Marge Schmuckal - shed permit

From: Marge Schmuckal
To: cwilly@maine.rr.com
Date: 7/19/2013 12:15 PM
Subject: shed permit

14 Anthony

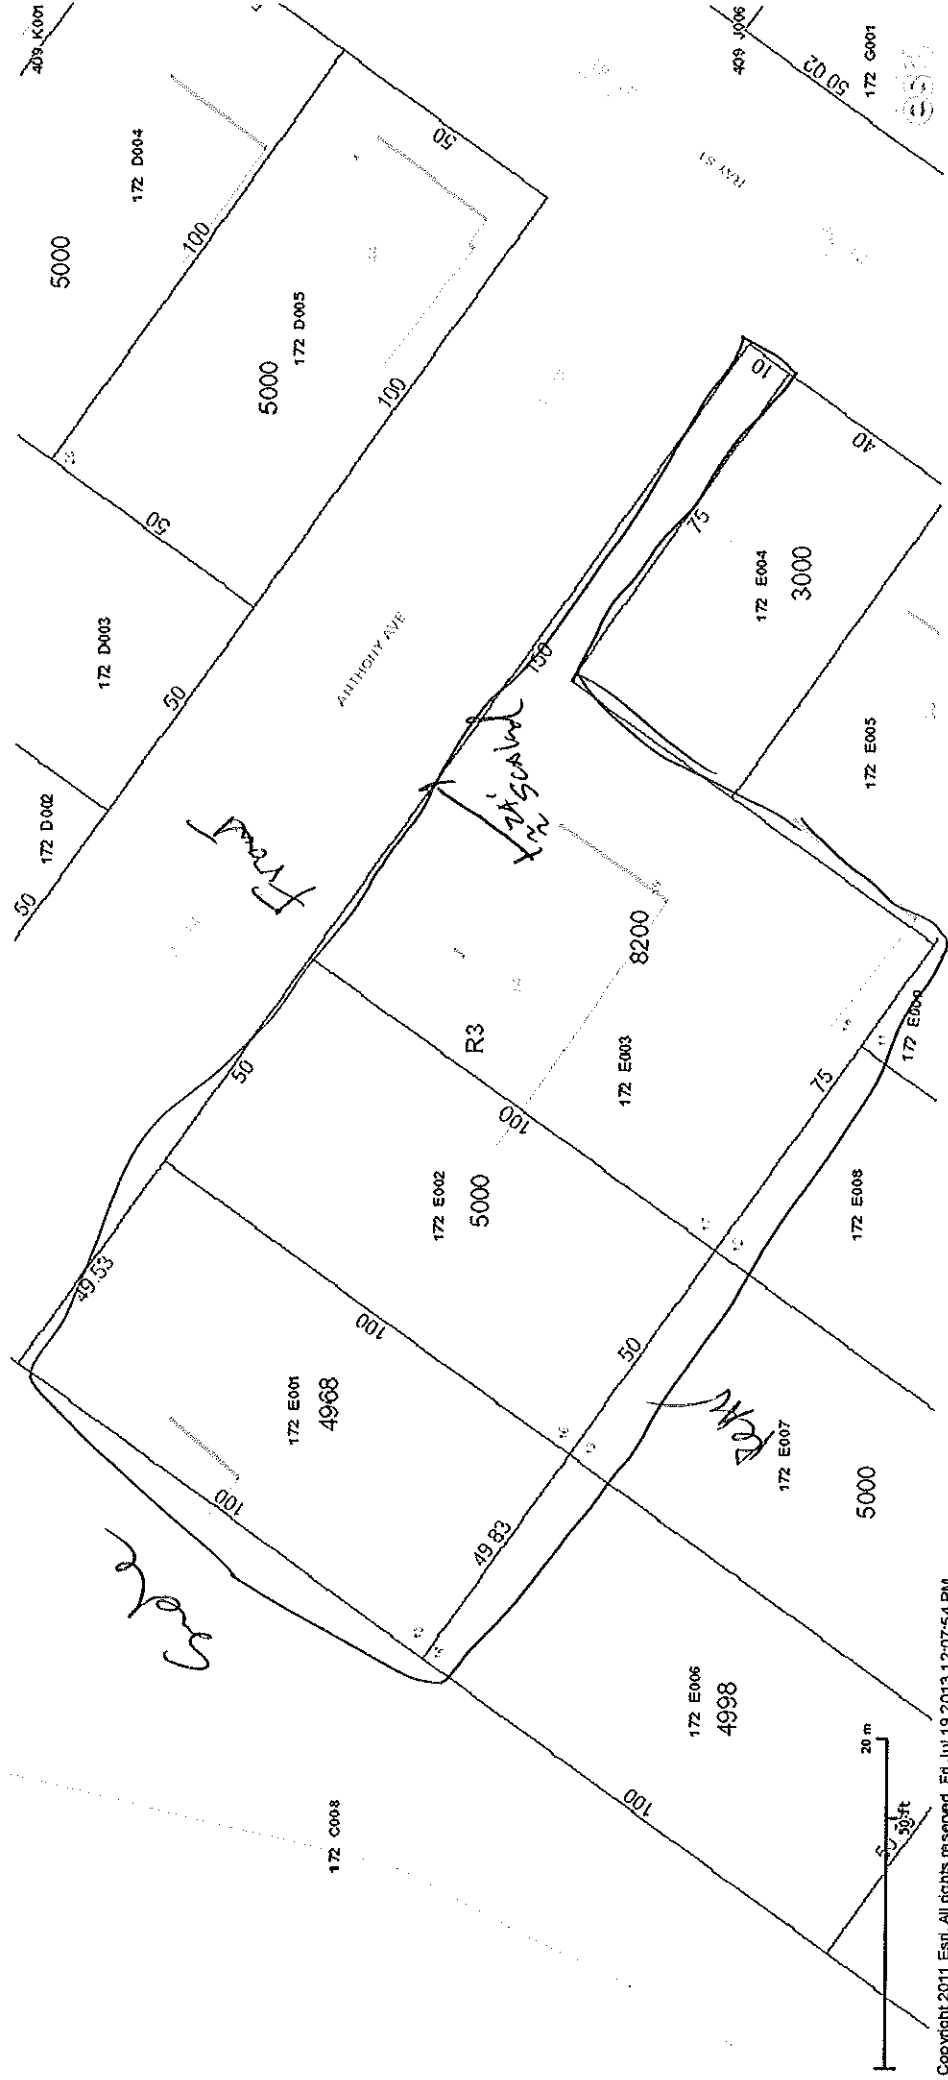
Hi Catherine,
thank you for getting your application in within a timely manner. There may have been a misunderstanding about the setbacks. Yes, the side setback is allowed to be 8 feet. But the front along Anthony is required to be 25 feet, not the 8 feet allowed on the side. Is it possible to revise your plans to show the required 25 feet along Anthony Avenue? You can e-mail the revised plans to me.

I have to put your permit on hold in the mean time.
Thank you,
Marge Schmuckal
(207) 874-8695
